# SERVICE BULLETIN

No. 222A

- SUBJECT:** Removal of Restriction to Air Speed Limits  
(Replacement of Stabilator Torque Tube)
- MODELS AFFECTED:** PA-30 Twin Comanches, Serials 30-1 to 30-482 incl., 30-484 to 30-491 incl., 30-493, 30-494, 30-496 to 30-502 incl., 30-504, 30-505, 30-507 to 30-565 incl.
- NOTE:** Serial Numbers 30-483, 30-492, 30-495, 30-503 and 30-506 have been modified at the factory and require only removal of placard and temporary supplement to flight manual for compliance.
- COMPLIANCE DATE:** Prior to but not later than 10 hours of operation after receipt of stabilator torque tube.

## INSTRUCTIONS FOR REPLACEMENT OF TORQUE TUBE ASSEMBLY

STABILATOR TORQUE TUBE REPLACEMENT
SKETCH "A"
KIT 756 827
PIPER AIRCRAFT CORPORATION
LOCK HAVEN, PENNSYLVANIA

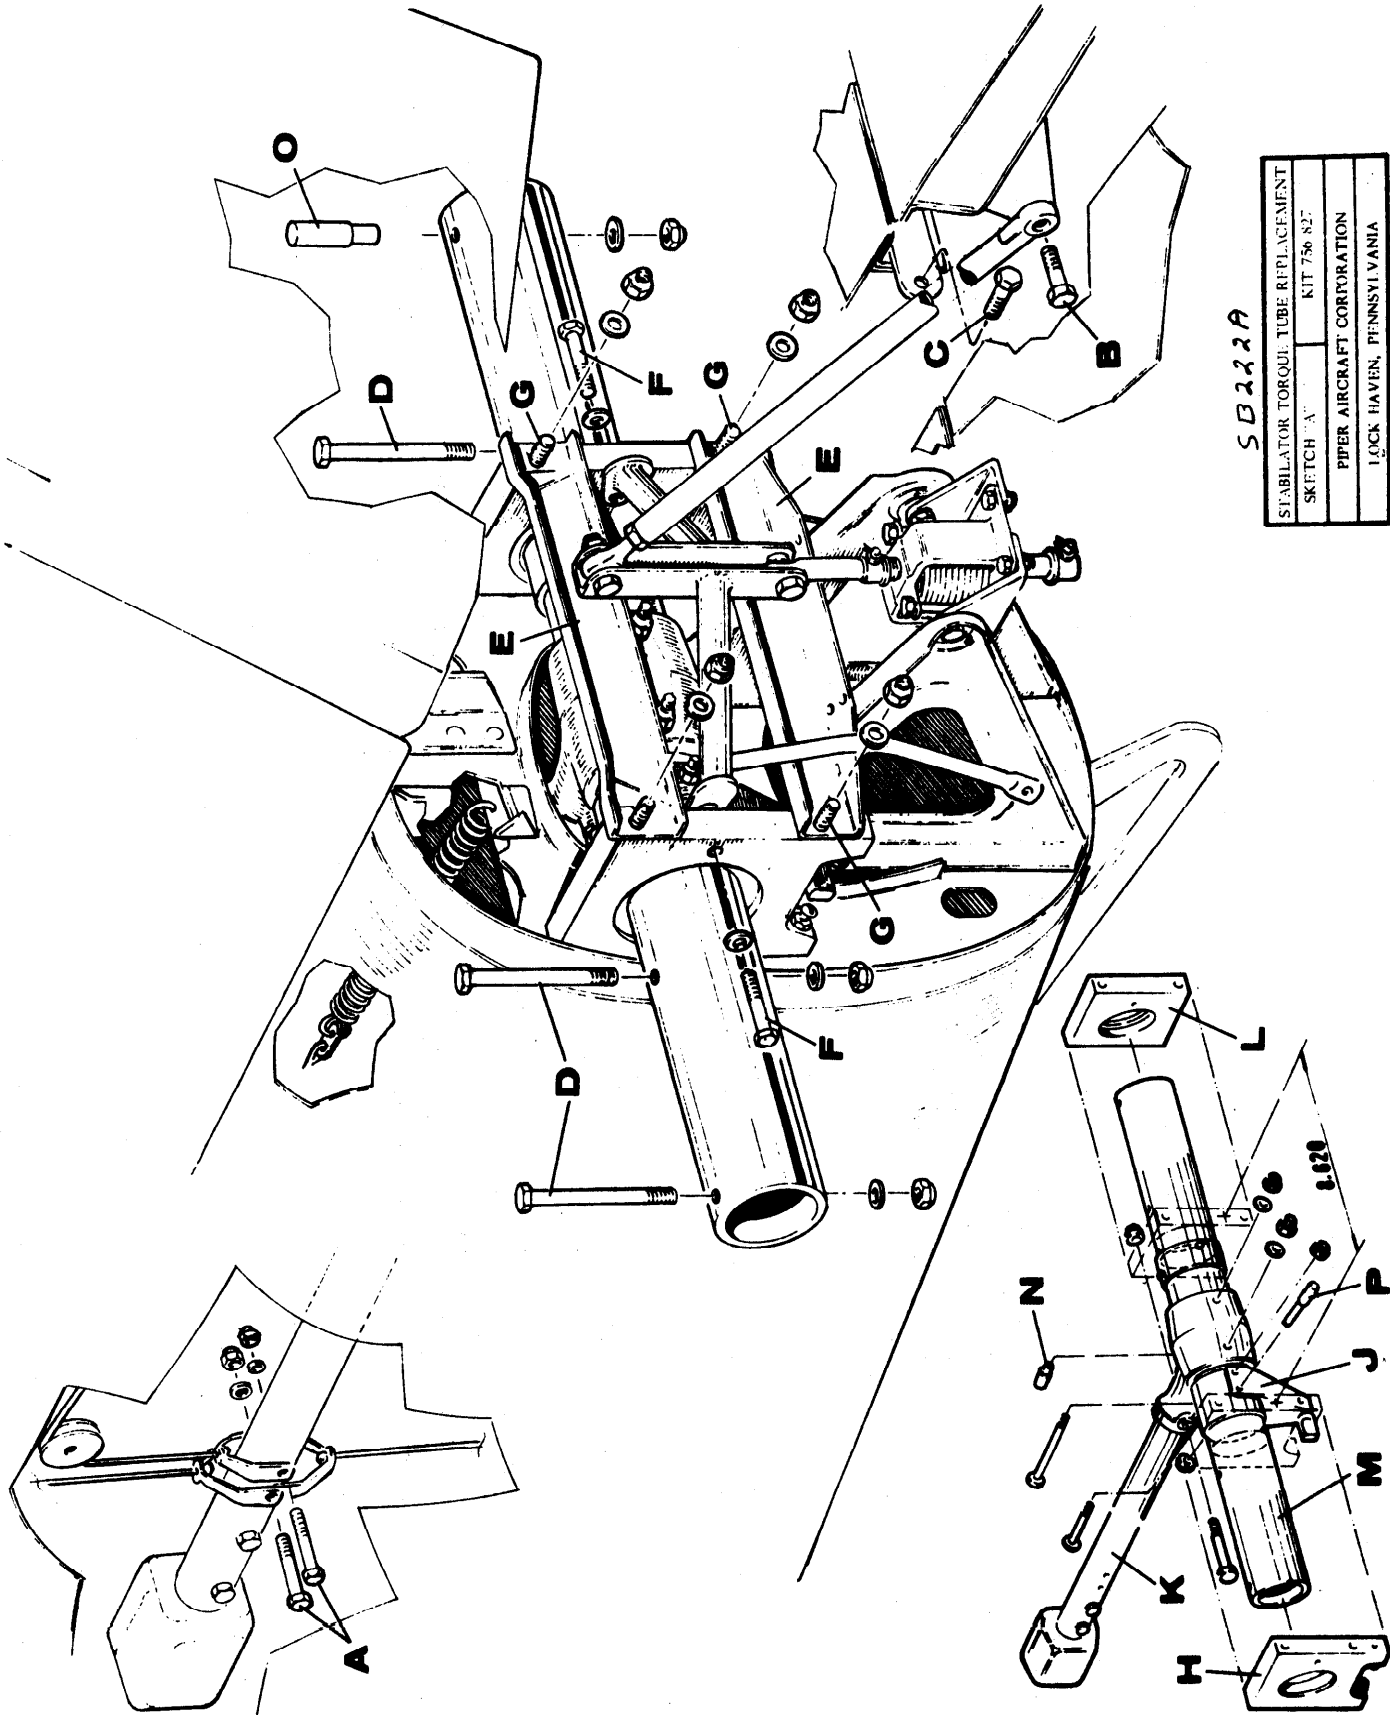
Owners and operators of the subject aircraft were advised recently that because vibration at approximately the red line not-to-exceed limit had been observed, it was necessary to restrict the air speed.

It has been determined that a stabilator torque tube, part number 22655-07, of heavier wall thickness will eliminate this vibration.

A new stabilator torque tube of heavier wall thickness will be provided to the owners of these aircraft as a replacement on a no charge basis.

16. Install counterbalance arm assembly on new stabilator torque tube, part number 22655-07. Note position in View B. Item M.

When counterbalance arm is in position, insert locating pin, part number 25034-00 in one hole until the shoulder bottoms on the torque tube.

Ream the other hole in the tube to .3120 to .3130. Insert bolt in reamed hole before removing locating pin to ream the second hole.

Holes drilled in the torque tube assembly are undersize and will be line reamed on assembly. Since the holes in stop assembly have already been reamed, a special locating pin, part no. 25034-02, is included with each torque tube to insure proper fit of these assemblies. Item P.

Ream the other hole in the tube to .2465 to .2475. Insert bolt in reamed hole before removing locating pin to ream the second hole.

Shims, part no. 81262-72, should be installed with bearing blocks in same position as when removed to maintain a dimension of 8.620 shown in View C.

19. Reinstall torque tube assembly on aircraft in reverse order of disassembly.
20. Install stabilators and bolt the rear spar. Insert locating pin in same manner as previously used in one hole on either stabilator. Ream the other hole to .3120 to .3130 and install bolt. Item O.
